OFFICE OF PUBLIC WORKS

MEETING DATE: July 26, 2021

PROJECT: Lake Lowell Ave. Rebuild – 12th Ave. to Wilson Path

SUBJECT: Residents Neighborhood Meeting

Figure 1 - City of Nampa Functional Class Map Excerpt

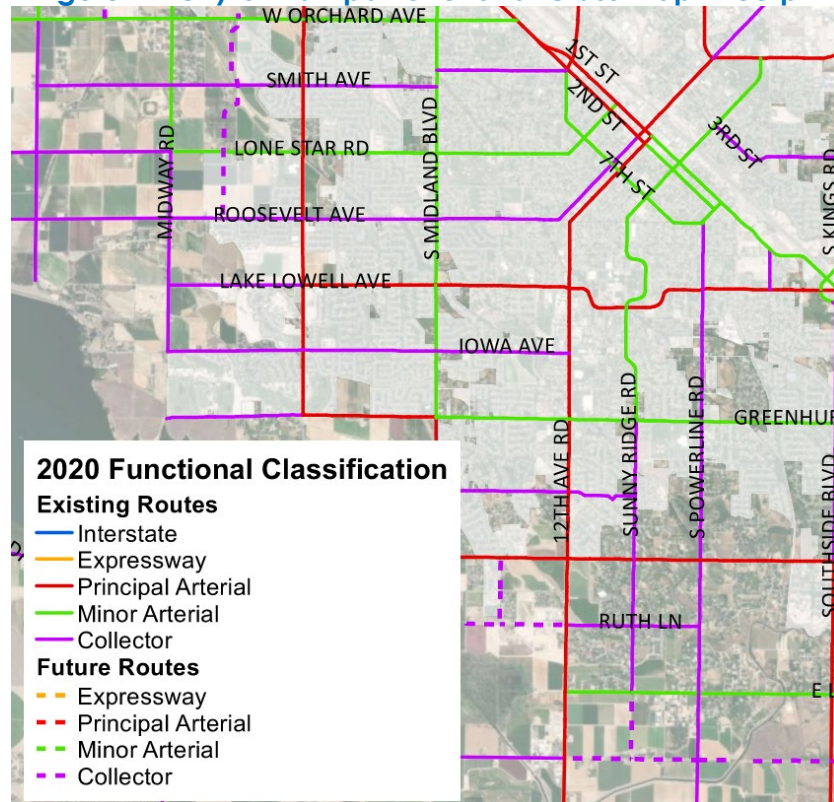
How did the City of Nampa determine this portion of Lake Lowell needs to be classified as an arterial?

Lake Lowell Avenue has been identified as an arterial roadway through several iterations of the City's transportation master plan, the City's historic roadway and street functional class map and the Community Planning Association of Southwest Idaho (COMPASS) long range planning for the Ada and Canyon County Metropolitan Area. Lake Lowell Avenue is an important piece of the City's grid system of collector and arterial roadways. As an arterial roadway, Lake Lowell Avenue is recognized for regional connectivity to the Lake Lowell Reservoir area, Idaho Highway 45 and connectivity into eastern Ada County via Amity Avenue. Below is a snapshot of the local area roadway functional classification for reference:
